## PROPOSED RESIDENTIAL DEVELOPMENT, BIRDY BROW, CHAIGLEY, CLITHEROE HIGHWAYS NOTE - OCTOBER 2025

Eddisons have been instructed by Mr David Dennis to advise on the transport and highways matters relating to a planning application for a replacement dwelling at Kemple Down, Birdy Brow in Chaigley, Clitheroe.

project	project number	drawing number
<b>Kemple Down</b>	<b>23.61</b>	<b>PL.07</b>
name	proposed highways plan	
scale	status	revision
1:100 and 1:1250 @ A1	february 2025	planning application

DRAWING TITLE:  
**PROPOSED SITE ACCESS**

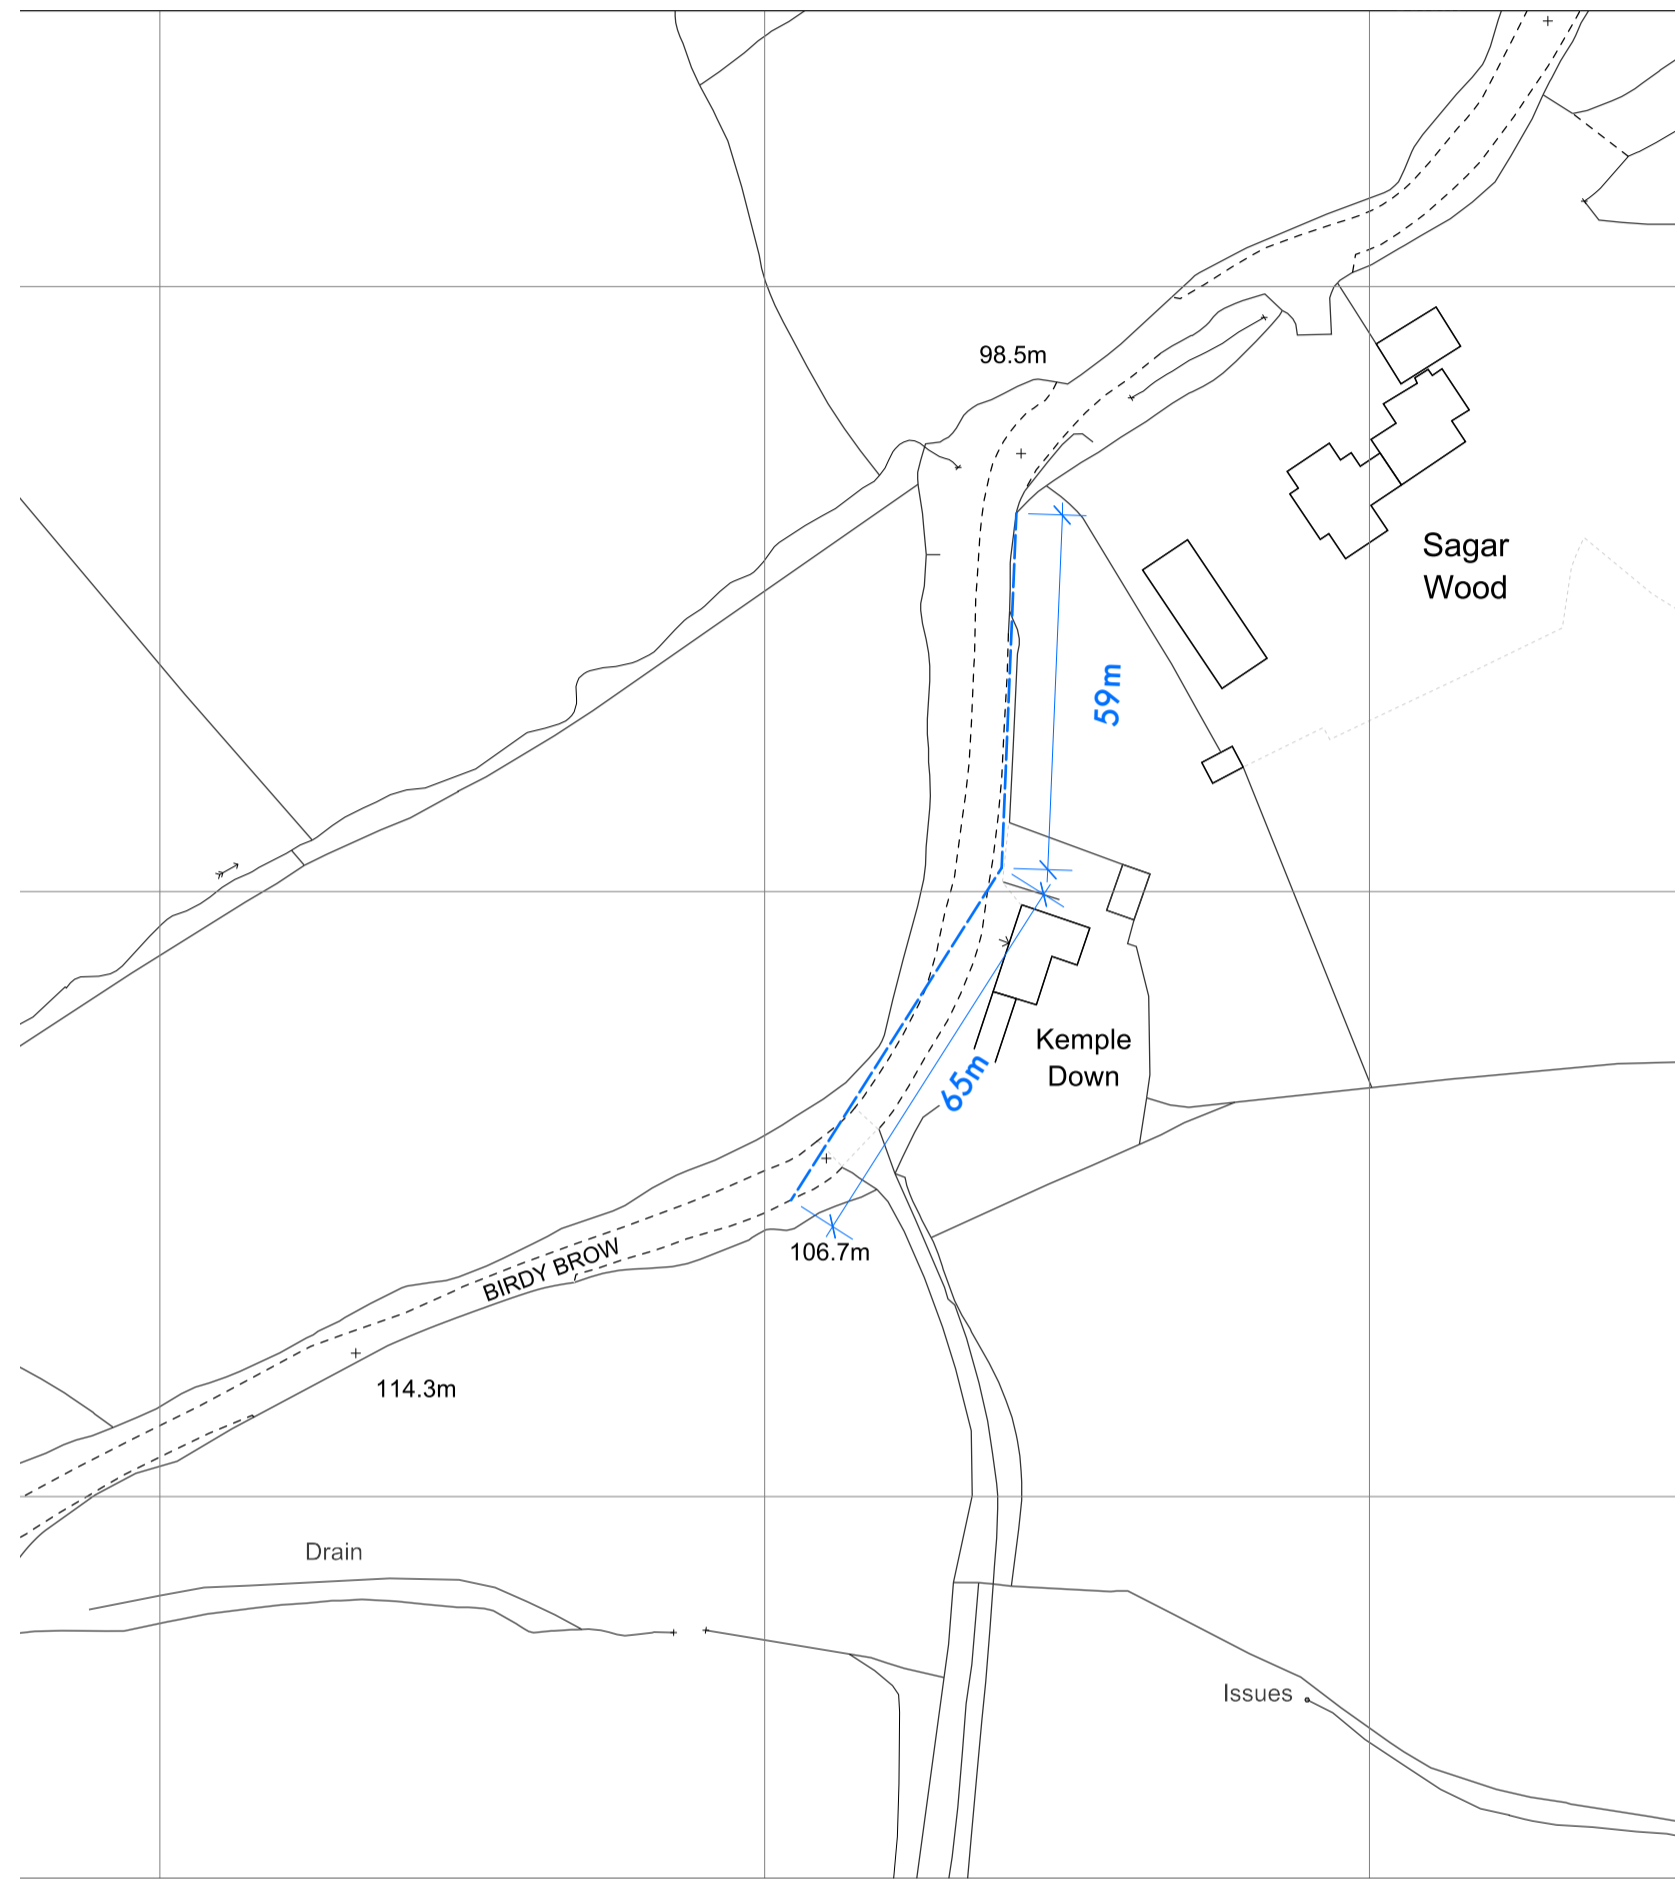
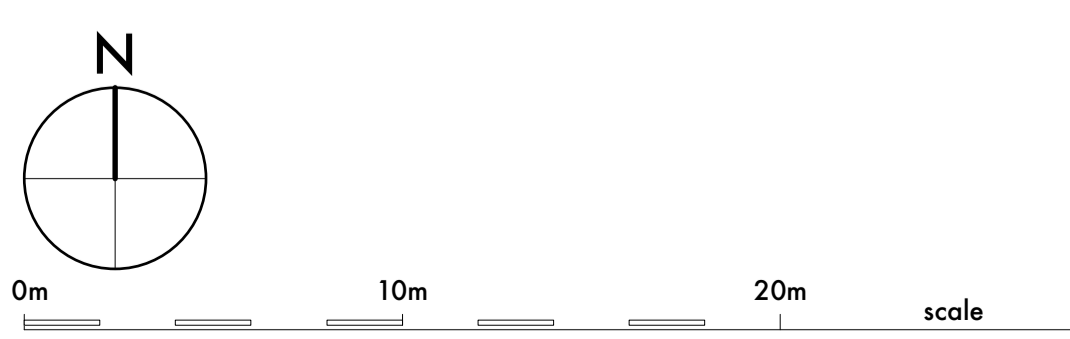
In conclusion, the officer advised that *'the current proposal to remove the southern access raises concerns due to its superior visibility compared to the retained access. To address these concerns, it is imperative that the applicant submits a detailed visibility splay drawing that clearly delineates the maximum achievable splay in both directions'*.

The proposal for the north access as shown on drawing PL.07 Revision A, will result in an improved surface material, widening to support turning provisions and access to a proposal garage. Drawing PL.07 Revision A, also shows a visibility splay and whilst this does not meet the posted national speed limit, on-site observations noted lower vehicle speeds given the sites location close to natural bends within the road. There is also no footways or street lighting which will also contribute to lower speeds along the road.

The access to the north is already used for parking and there have been no Personal Injury Collisions recorded within 500m of the site in the last 5 years, therefore the LHA have no pre-existing highway safety concerns. Therefore, the reduced visibility splay which shows visibility for approximately 30MPH speeds is acceptable in this case.

A plan to show the maximum achievable visibility splays was provided in **Drawing ref no. 2361 PL07 Revision A** and is included in this Note for ease of reference. The plan shows that based on the location of the proposed access point, visibility splays of 59 metres to the north and 65 metres to the south could be achieved.

In regard to the visibility splays detailed above, the officer acknowledges Drawing PL07 Revision A and notes that it *'shows a visibility splay and whilst this does not meet the posted national speed limit, on-site observations noted lower vehicle speeds given the sites location close to natural bends within the road. There is also no footways or street lighting which will also contribute to lower speeds along the road'*.

*'The access to the north is already used for parking and there have been no Personal Injury Collisions recorded within 500m of the site in the last 5 years, therefore the LHA have no pre-existing highway safety concerns. Therefore, the reduced visibility splay which shows visibility for approximately 30MPH speeds is acceptable in this case'*.

2. No use hereby permitted shall commence until visibility splay of 2.4 metres back from the centre line of the access and extending 59 metres to the north of the access and 2.4 metres back from the centre line of the access and extending 65 metres to the south of the access along the nearside carriageway edge have been provided, as shown on the approved plans. Nothing shall be erected, retained, planted and / or allowed to grow at or above a height of 0.9 metres above the nearside carriageway level which would obstruct the visibility splay. The visibility splays shall be maintained free of obstruction at all times thereafter for the lifetime of the development.

DRAWING NUMBER: **5017-F01**      REVISION: **-**

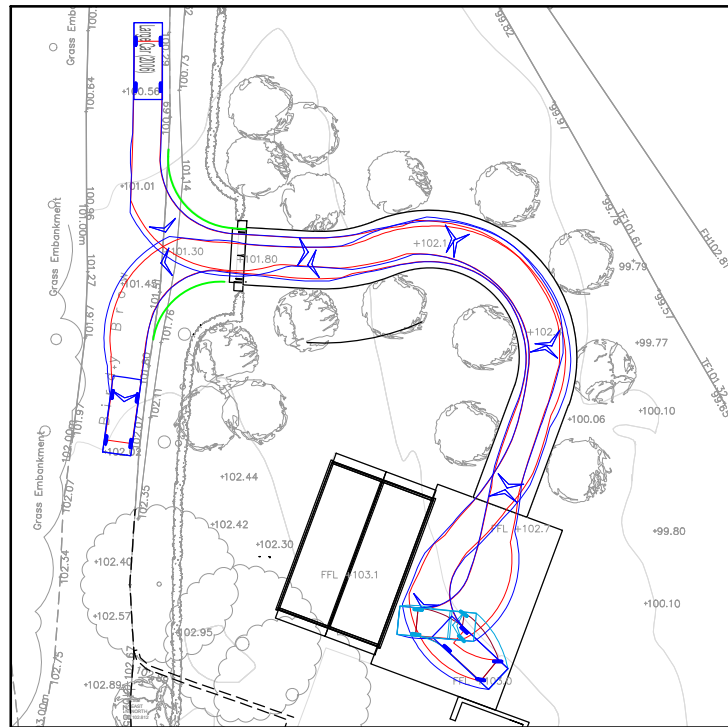
Clearly, the southern visibility splay accords with the distance required by LCC, however, as the new access is now situated further north, the visibility distance available is reduced to 37.6 metres.

Whilst below the 59 metres previously considered acceptable, it is Eddisons view that the access is justified, would still operate in a safe and efficient manner and would not give rise to any highway safety issues.

- The site is currently served by 2no. points of access, so the proposals consolidate these to result in just one access.
- The site is already generating vehicle movements onto Birdy Brow.
- There are various similar access points serving other residential properties in the vicinity.
- Traffic along Birdy Brow is likely to be very local, with drivers making habitual journeys and so will be well aware of the potential for vehicles to be exiting properties along there.
- The close proximity of the bend in the road to the north will have the beneficial effect of reducing traffic speeds.
- The narrow, rural nature of Birdy Brow, also lends itself well to promoting slow speeds.

- Similarly, given there are no footways or street lighting, drivers are most likely to be travelling well below the National speed limit.
- There have been no recorded accidents in the vicinity of the site over the last 5 years.
- The area does not therefore have a poor safety record.
